RE: Concerns Regarding Proposed Pinnacle at Liberty Bay PRD Adjacent to Crystal View - Request for Compliance with PMC 18.260.070 (A) and (B).

From: [Tracie hannah](#)
To: [Tiffany Simmons](#); [Tracie hannah](#)
Subject: Request for Clarification on Pinnacle at Liberty Bay PRD Compliance with RL Zoning Standards
Date: Monday, August 25, 2025 9:11:59 AM
Attachments: [image.png](#)
[image.png](#)
[image.png](#)

PINNACLE AT LIBERTY BAY PLANNED RESIDENTIAL DEVELOPMENT AND PRELIMINARY PLAT

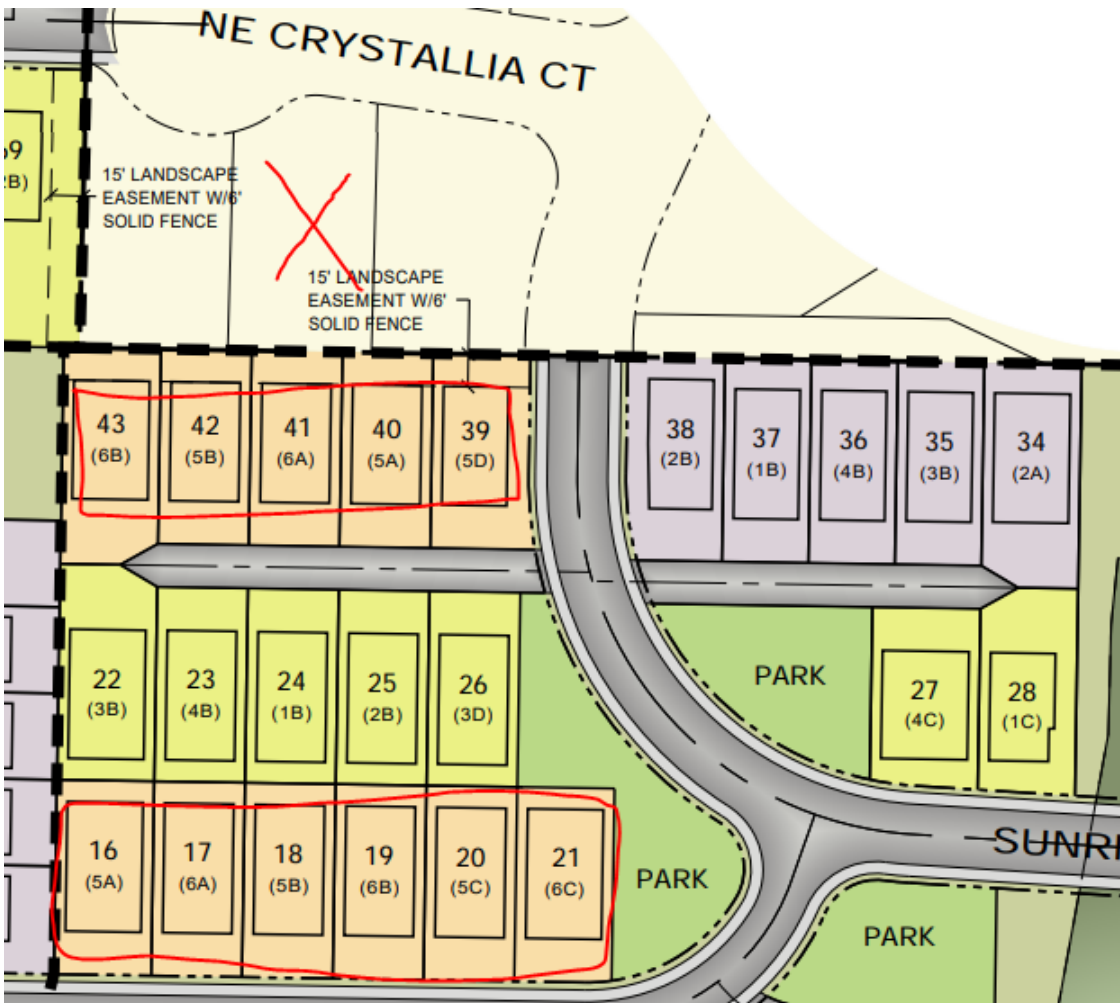
The proposal indicates three-story homes ranging from 37 to 39 feet in height — and these taller homes appear to be placed only in the row directly in front of our Crystal View neighborhood, which would block existing water views and diminish property values by an estimated \$50,000 or more per home. This raises the question of why homes exceeding the 35-foot maximum are being considered at all, and why they are concentrated specifically where they will have the greatest negative impact on existing homeowners.

1. How does the proposed development plan comply with PMC 18.70.050, particularly regarding lot size adjacency requirements?
2. Will the City require that all lots adjacent to existing homes meeting the 7,500 sq. ft. minimum also meet this same standard?

3. How are the lot width (50 ft.), lot depth (80 ft.), and maximum building height (35 ft.) requirements being applied in the proposed site plan?
4. On what basis would homes taller than 35 feet (up to 39 feet) be permitted, when the RL zone code prohibits structures exceeding 35 feet?
